**TOWN OF NEWBURGH  
PLANNING BOARD  
TECHNICAL REVIEW COMMENTS**

**PROJECT:** ADS PROPERTIES/SHEELEY CAR WASH  
**PROJECT NO.:** 21-04  
**PROJECT LOCATION:** SECTION 95, BLOCK 1, LOT 14.1  
**REVIEW DATE:** 11 NOVEMBER 2021  
**MEETING DATE:** 18 NOVEMBER 2021  
**PROJECT REPRESENTATIVE:** PIETRZAK & PFAU

Re: ADS Properties, LLC Carwash  
PB Project No. 2021-04  
P&P No. 31102.01

Express Car Wash Town of Newburgh, Orange County, NY  
 Colliers Engineering & Design Project No. 21000865A

**UTILITY PLAN**  
SECTION 95 BLOCK 1 LOT 14.1

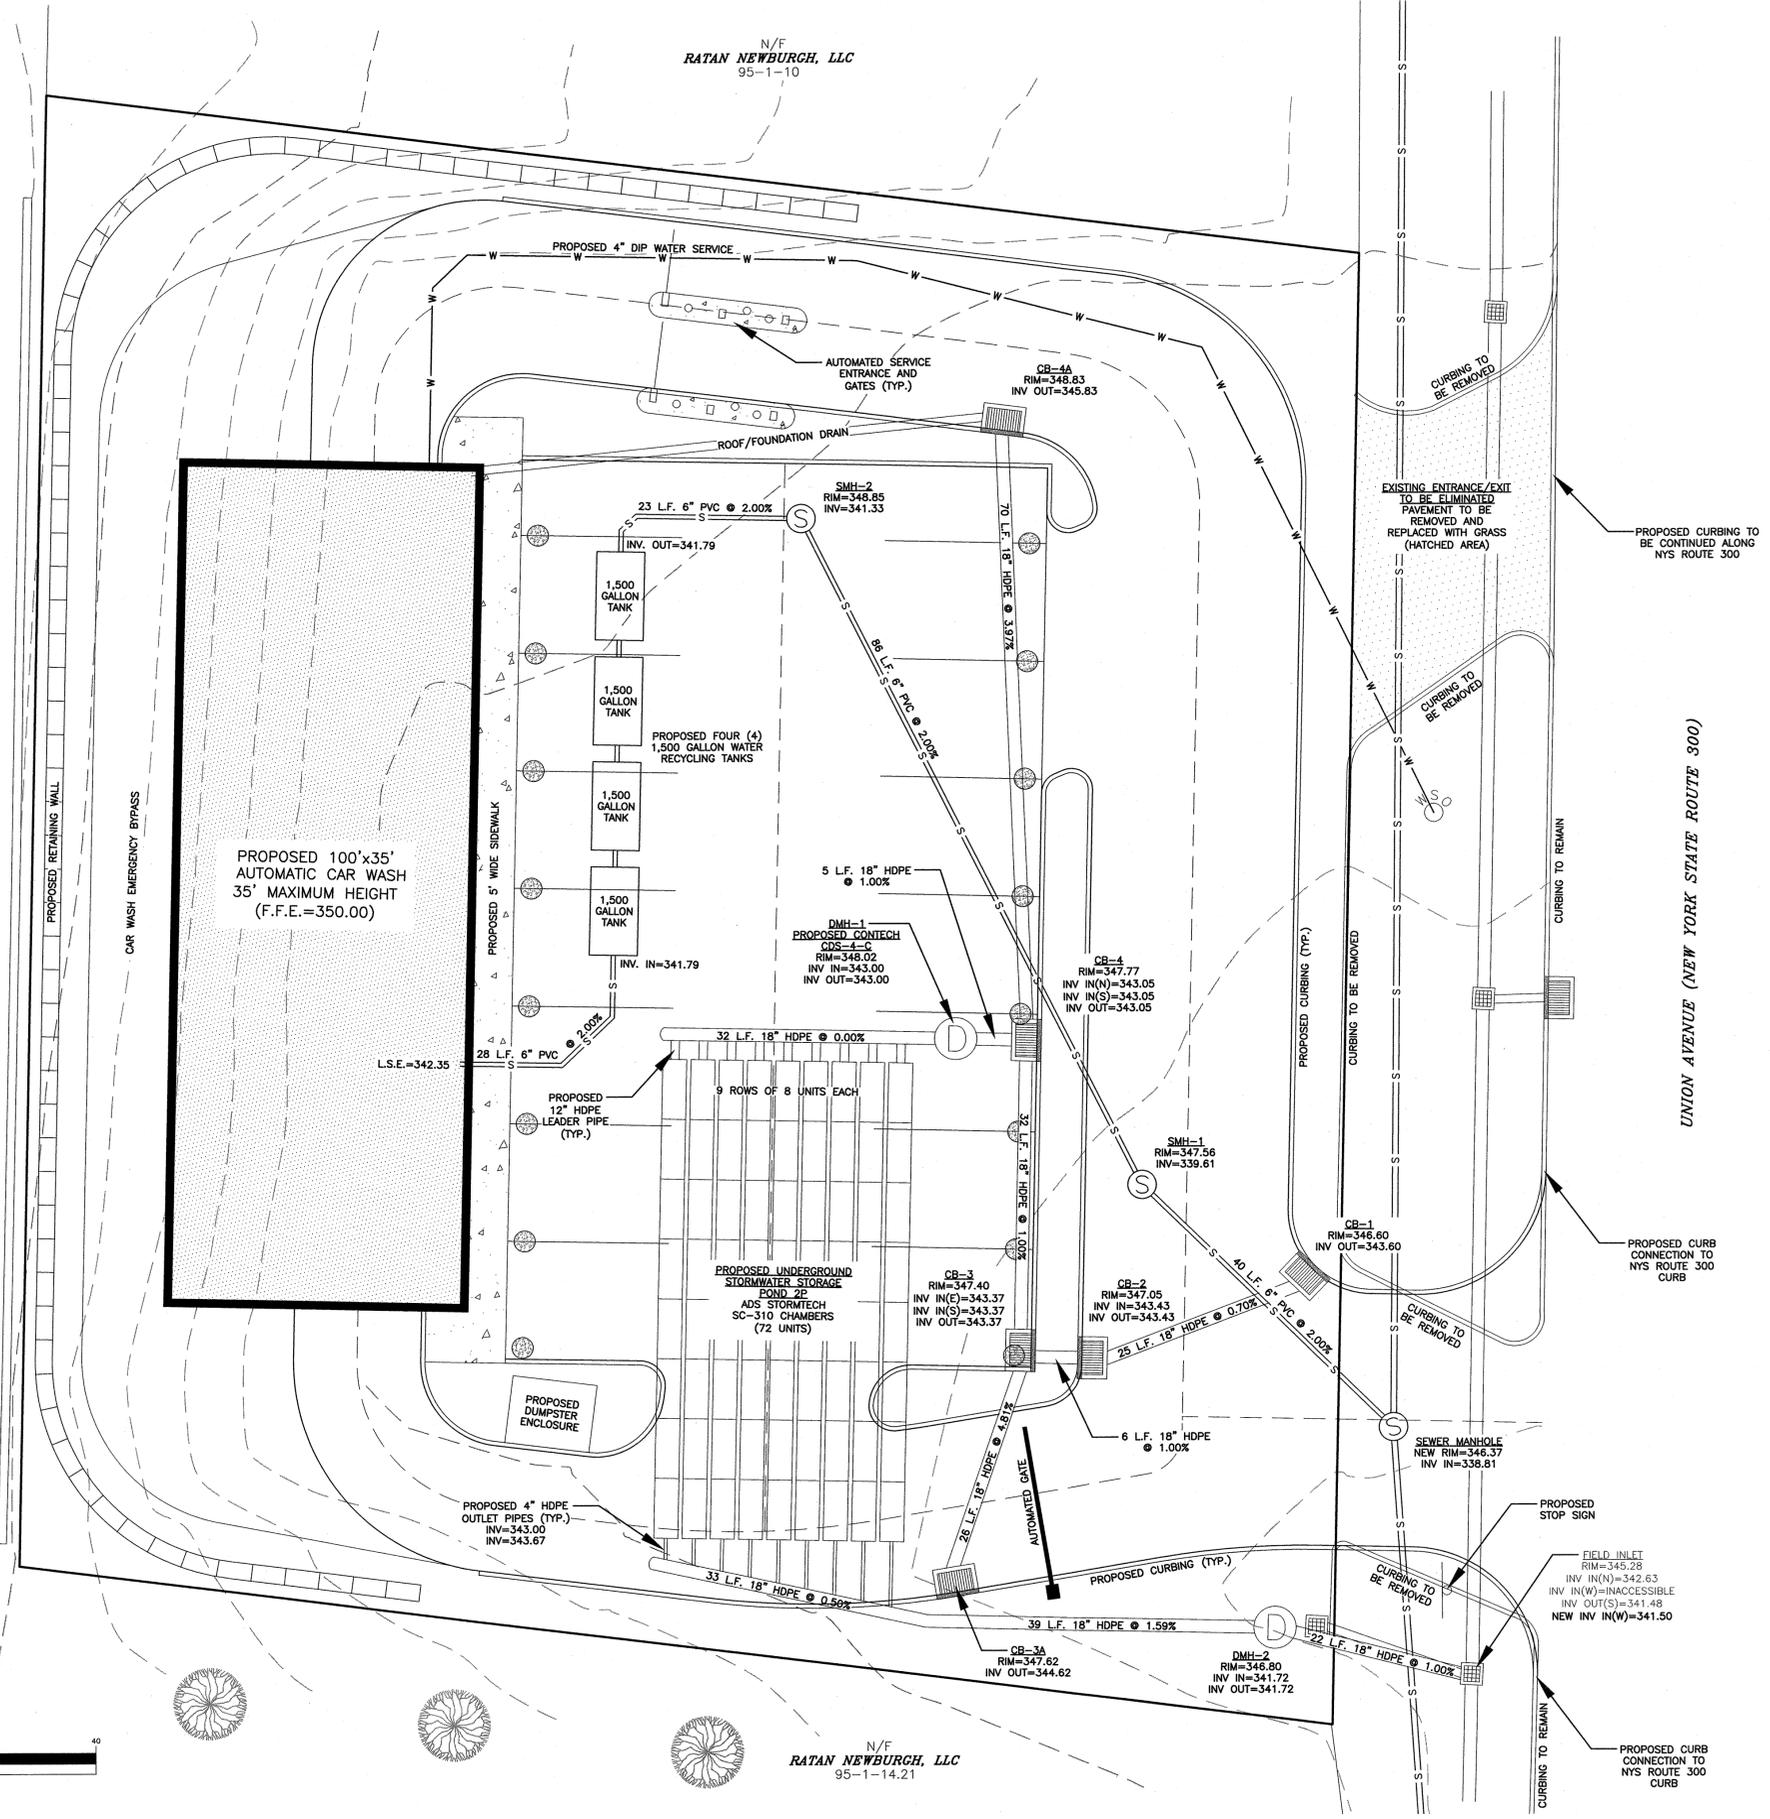
6. The 6 inch sanitary lateral should be connected to the sewer main and not in a sewer manhole. Connections to the sanitary sewer should be made outside of manholes which are provided for access for cleaning and maintenance.

7. A water main connection detail should be provided for the wet tap of the Town water main.
8. Location of the water main should be depicted on the plans.

9. The proposed water service has been revised to show a 4" ductile iron water line.
10. Comment Noted.
11. Comment Noted.
12. Comment Noted.
13. A geotechnical engineering report is currently being completed for the retaining wall designers. A stamped design will be submitted to the Building Department prior to construction.

14. All vacuum units have now been shown on the updated plans.
15. Comment Noted.
16. Our office is currently working with the Town Engineer to provide the required details with regard to construction of the proposed 4" ductile iron water line.

**TERRA-CRETE BLOCK RETAINING WALL DETAIL**  
N.T.S.

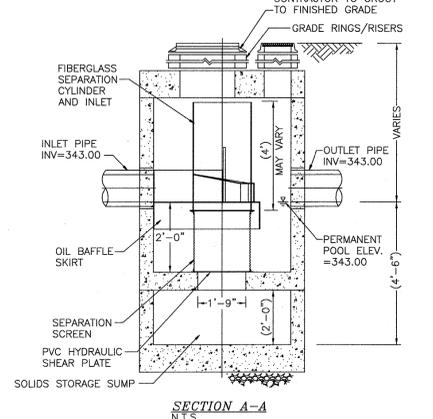
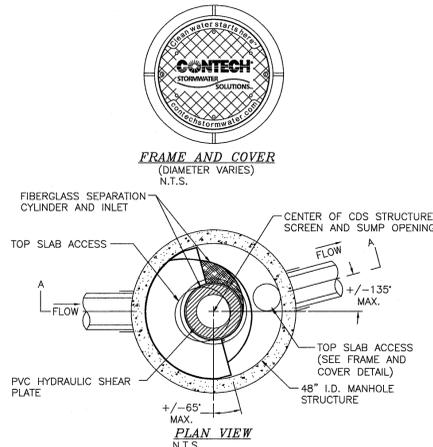
3. Notes should be added to the plans requiring submission of a retaining wall design stamped by a NYS Design Professional prior to issuance of Building Permits on the site.
